# NACIMIENTO WATER PROJECT

Addendum No. 1 to Final Environmental Impact Report

Prepared for:  
County of San Luis Obispo

Revised November 2007

**Figure 1**  
Nacimiento Lake Drive

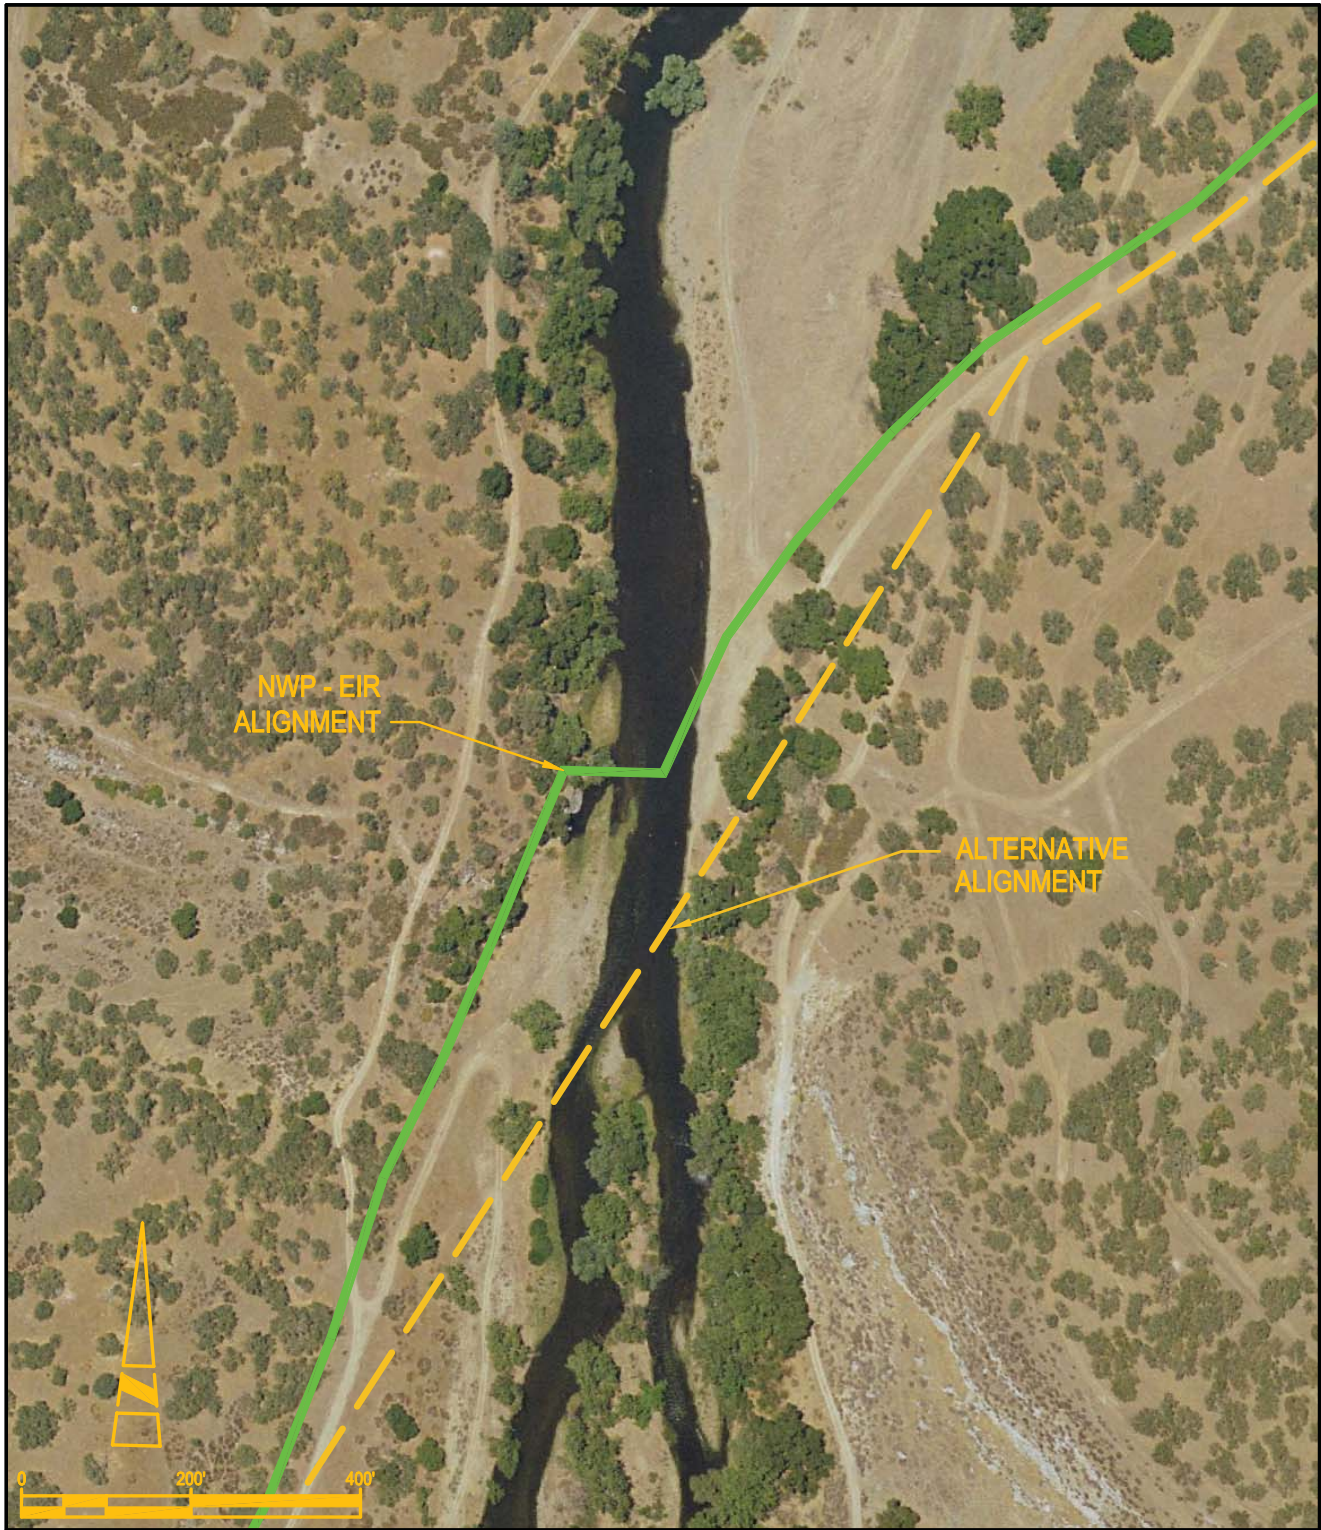
In the Final EIR, the segment of pipeline between Stations 5+00 and 15+00 crosses Nacimiento Lake Drive past the northern abutment of the Nacimiento Dam, and continues along the alignment of the existing paved road heading east (**Figure 1**). The paved road runs parallel to the dam's existing spillway on the north side of the Nacimiento River. The Monterey County Water Resources Agency (MCWRA) has expressed concern regarding safety of the dam and spillway and traffic disturbances associated with the pipeline construction along the paved road.

The proposed pipeline refinement would turn east from the Intake Pump Station, across Nacimiento Lake Drive, and continue over the hill north of the paved road. The pipeline would then rejoin and continue along the paved road. The proposed realignment would be constructed using open trench methods. This proposed modification would reduce traffic impacts along Nacimiento Lake Drive.

**Figure 3**  
Rabbit Ridge Winery

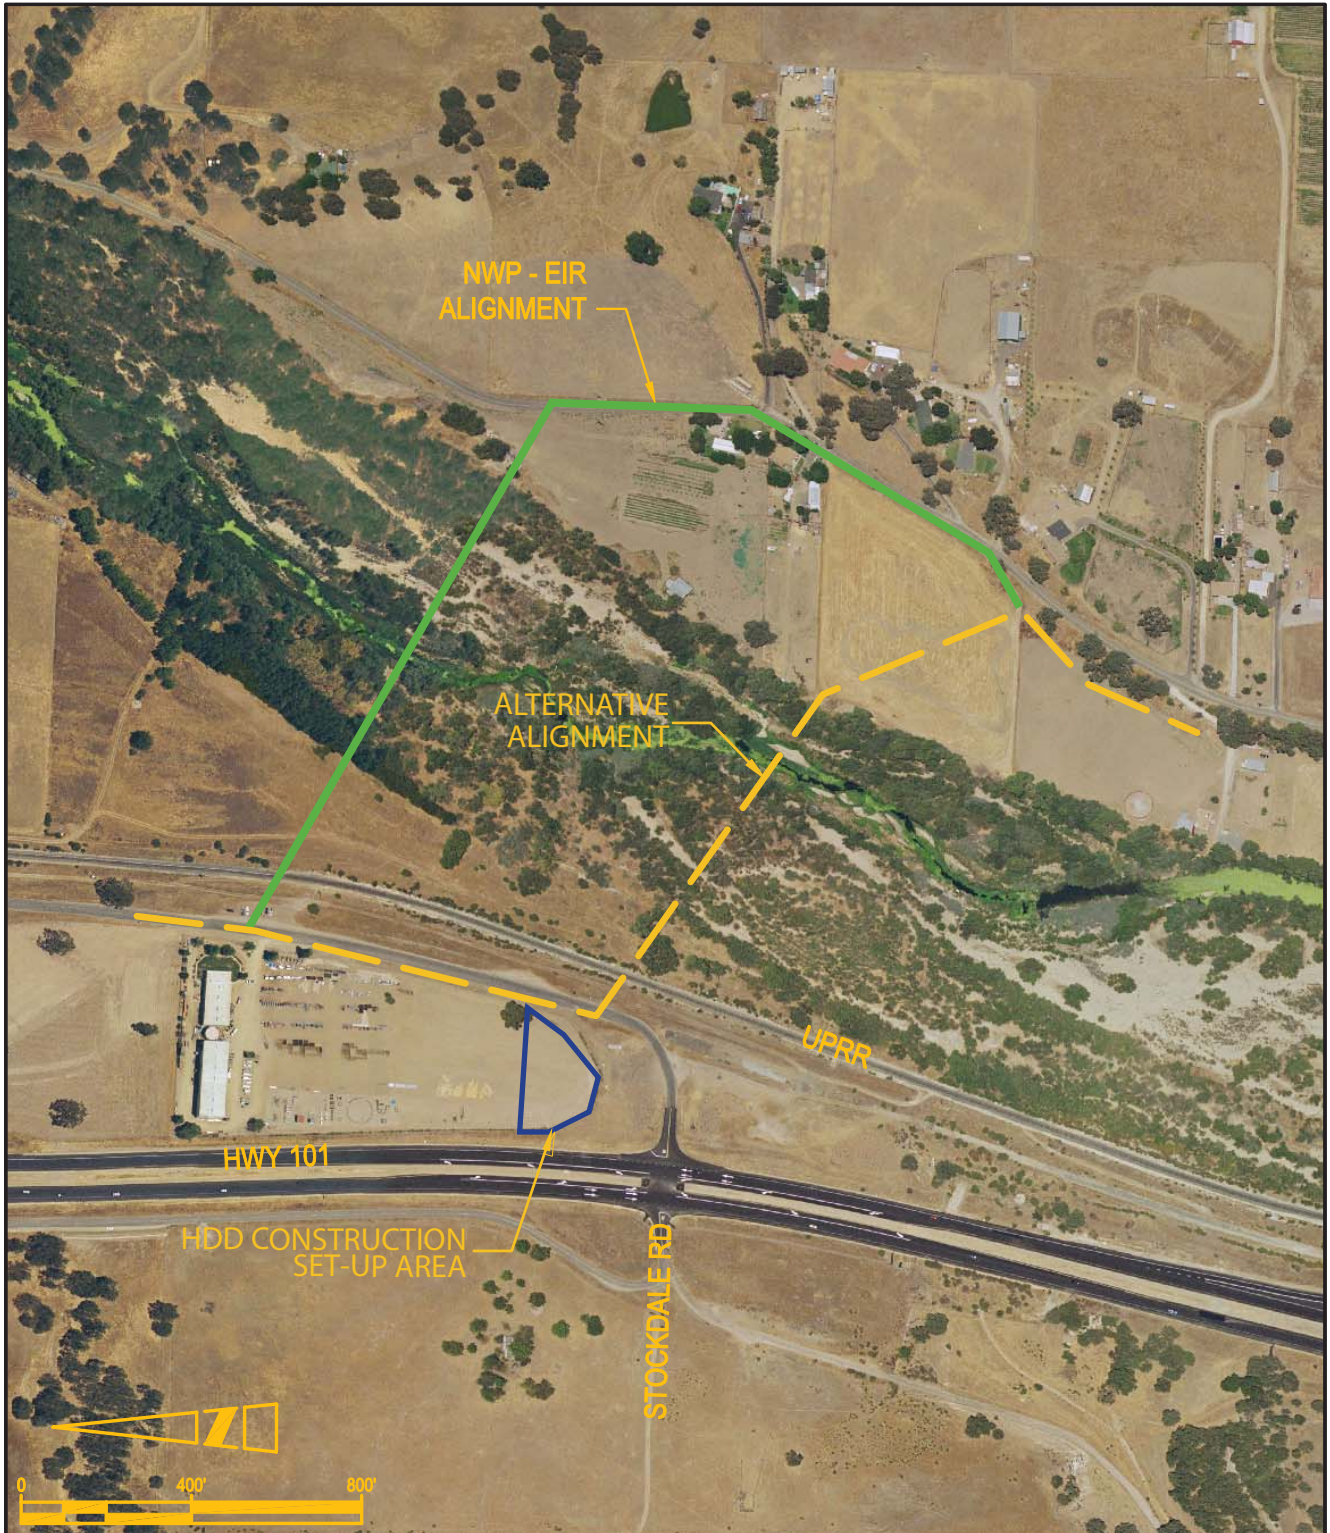
In the Final EIR, the segment of pipeline between stations 655+00 and 685+00 follows a private vineyard dirt access road to the west of Rabbit Ridge Winery (**Figure 3**). The pipeline runs east along the southern shoulder of the access road, crossing a jurisdictional ephemeral drainage then crossing a vineyard, and turning southeast to cross San Marcos Creek. The pipeline runs between San Marcos Creek and San Marcos Road and then crosses San Marcos Road to run along Wellsona Road.

The proposed refinement would shift the pipeline to the north to avoid the jurisdictional drainage on the vineyard access road. In addition, the proposed refinement would shift the pipeline further north near the winery and change the angle of the pipeline crossing of San Marcos Creek and San Marcos Road before reaching Wellsona Road. These modifications would reduce impacts to biological resources, and reduce disruption to the winery facilities and operations.

**Figure 4**  
Salinas River  
North Crossing

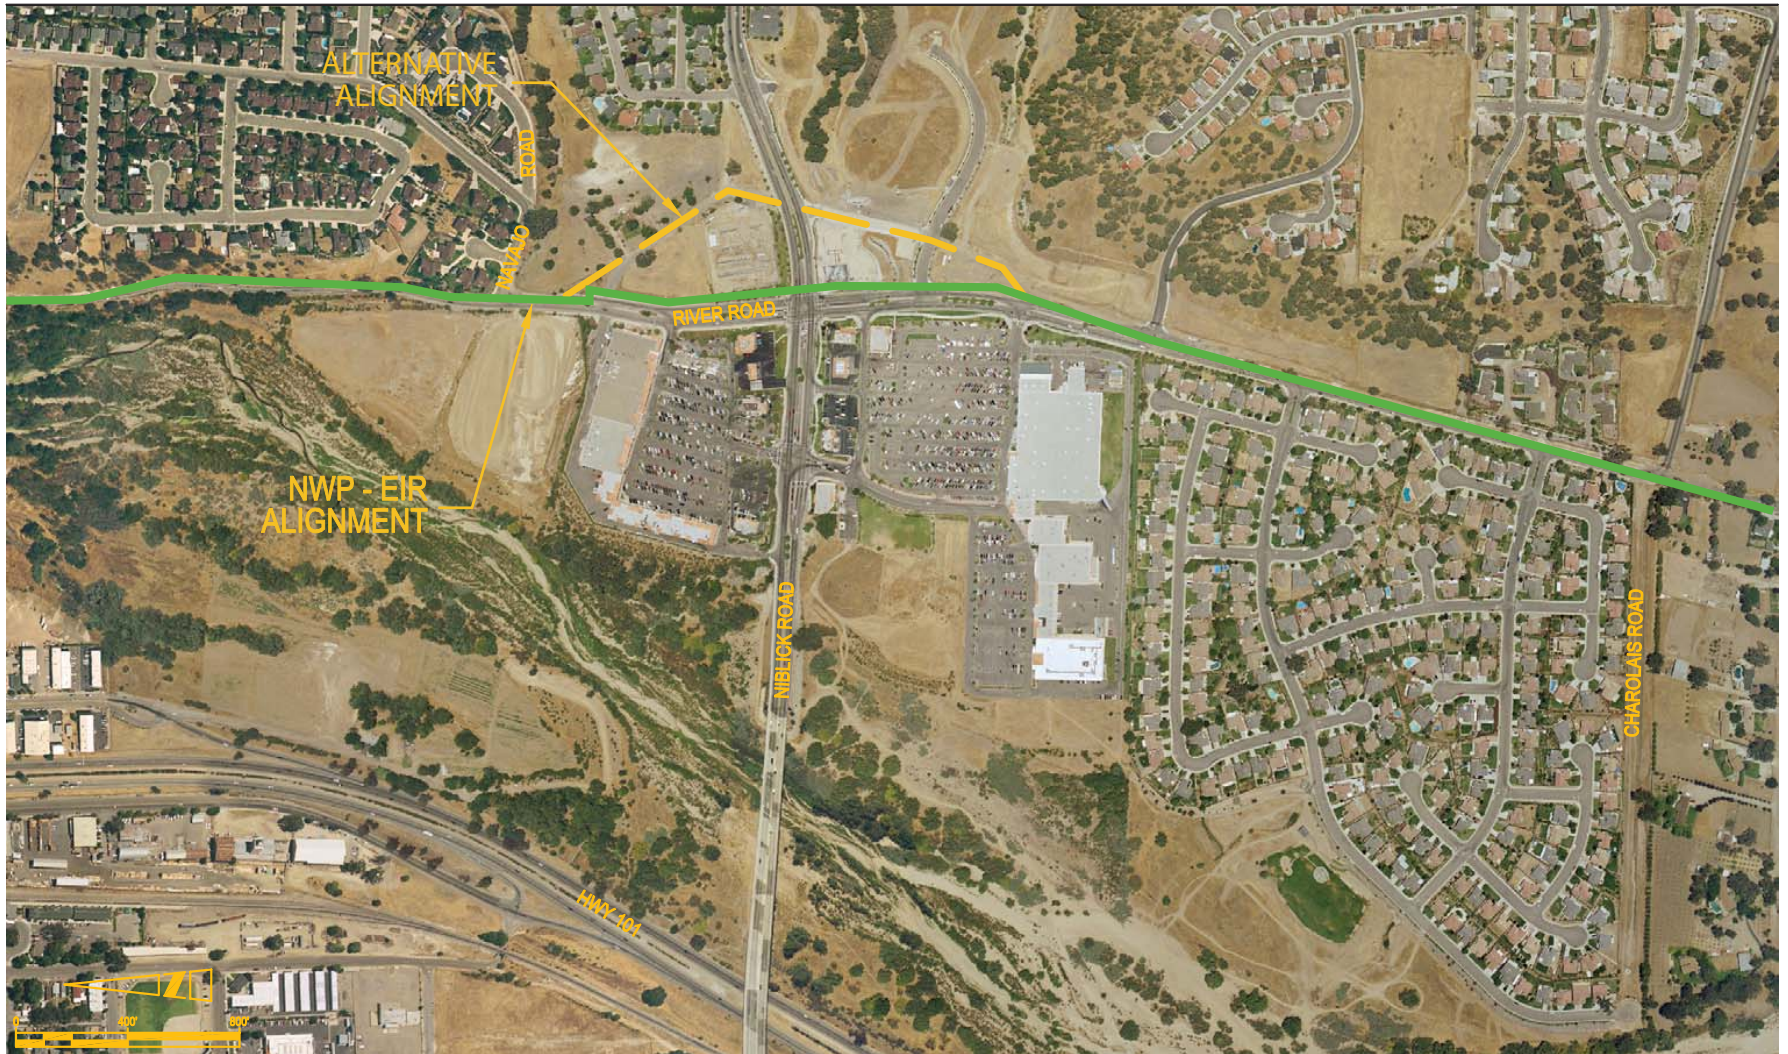
In the Final EIR, the segment of pipeline between Stations 875+00 and 895+00 runs south along the right-of-way on the west side of Monterey Road, then turns east to cross the UPRR and Salinas River (**Figure 4**). The river crossing requires the acquisition of easements from the private property owners on both sides of the river.

The proposed pipeline refinement would continue further south along Monterey Road about 100 feet north of the Highway 101 Stockdale Road Exit and then turn east across the railroad and river. As described in the Final EIR, HDD would still be used to install the pipeline across the railroad and river channel. This pipeline modification could reduce the number of private property owners affected by the project construction and reduce the number of trees removed on the east side of the river because the termini for the HDD drive equipment would be located in previously disturbed areas.

**Figure 5**  
Niblick Road

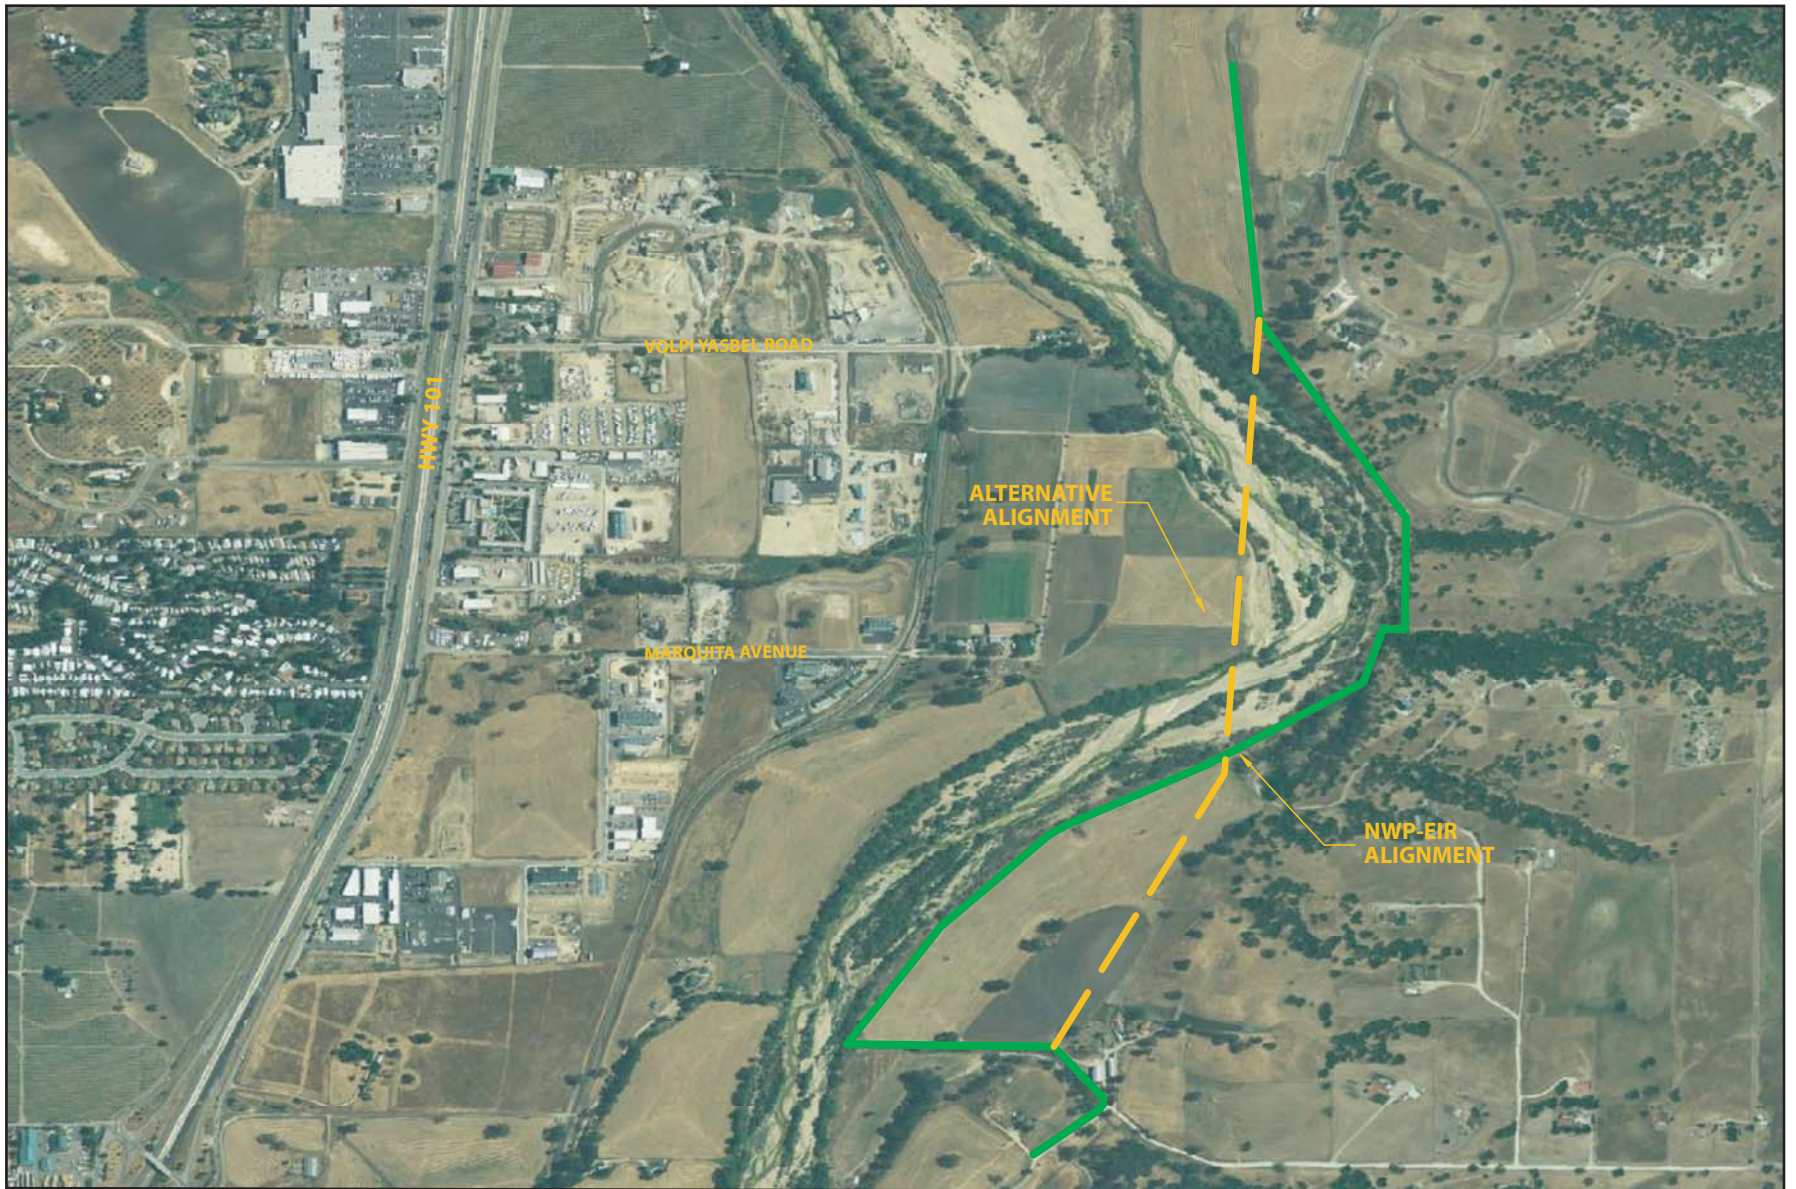
In the Final EIR, the segment of pipeline between Stations 1084+00 and 1130+00 runs along River Road through Paso Robles across the intersections with Niblick and Creston Roads (**Figure 5**). Open trench construction is used along the roadway, except for these two intersections where jack-and-bore construction is used due to heavy traffic.

The proposed refinement would avoid the intersection of Niblick and River Road by diverting the pipeline along old River Road, crossing Niblick Road further east. This modification would avoid the need for jack-and-bore construction and reduce the effects of construction on traffic at the Niblick/River Road intersection, including detours and lane closures.

**Figure 6**  
Salinas River  
Middle Crossing

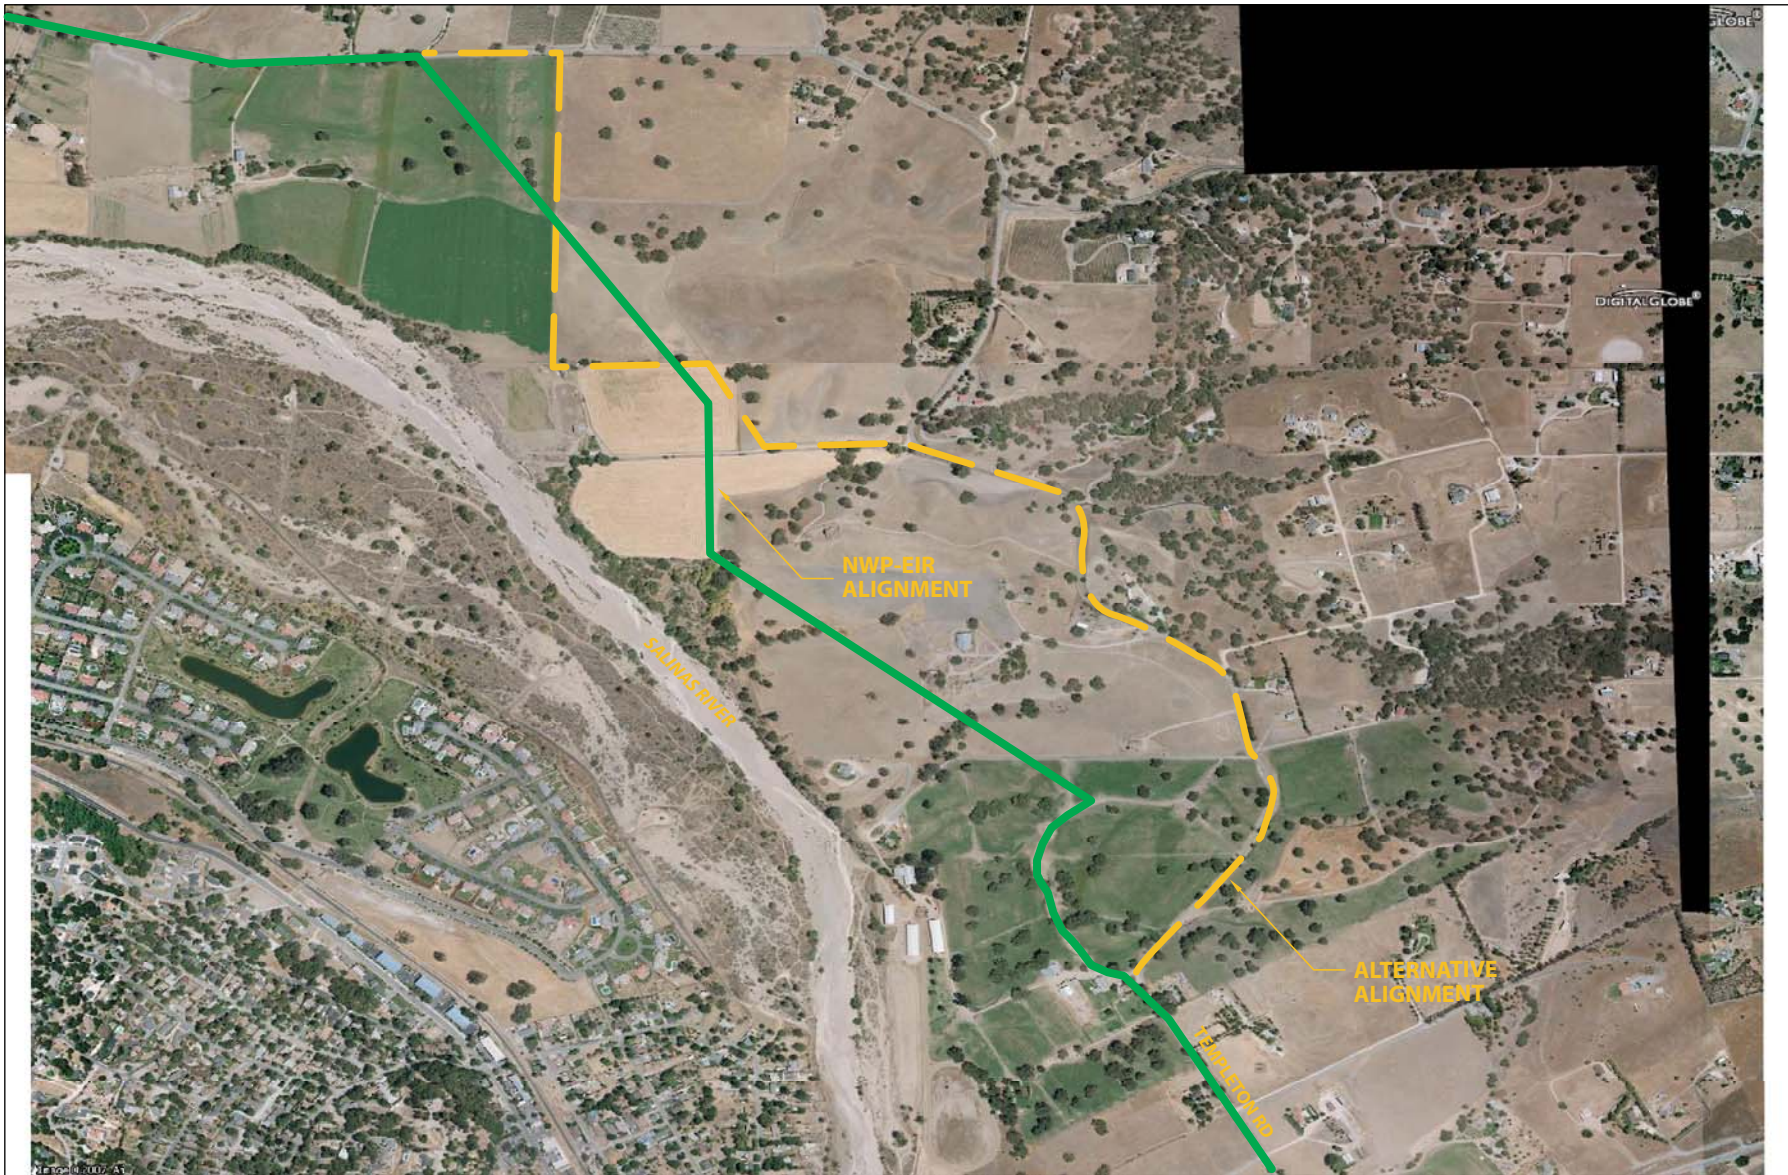
In the Final EIR, the segment of pipeline between Stations 1225+00 to 1300+00 reaches the banks of the Salinas River within Santa Ysabel Ranch and tunnels through the steep hillsides following the U-shaped bend in the river (**Figure 6**). The pipeline continues along the southeast side of the river, skirting private property, then turns east along a dirt road.

The proposed refinement would run straight across both legs of the U-shaped river bed. HDD construction methods would be used to make the entire crossing. This modification would reduce impacts to surface water quality because the alignment would no longer cross small tributaries in the hillsides adjacent to the river. In addition, avoidance of construction in this portion of the Salinas River would reduce potential disturbance of steelhead trout populations. On the south side of the river, the pipeline would emerge onto property recently acquired by SLO County. The pipeline would continue its southern route across this property joining the EIR alignment at approximately Station 1300+00 on the dirt road. Trenching methods would be used for this portion of the pipeline.
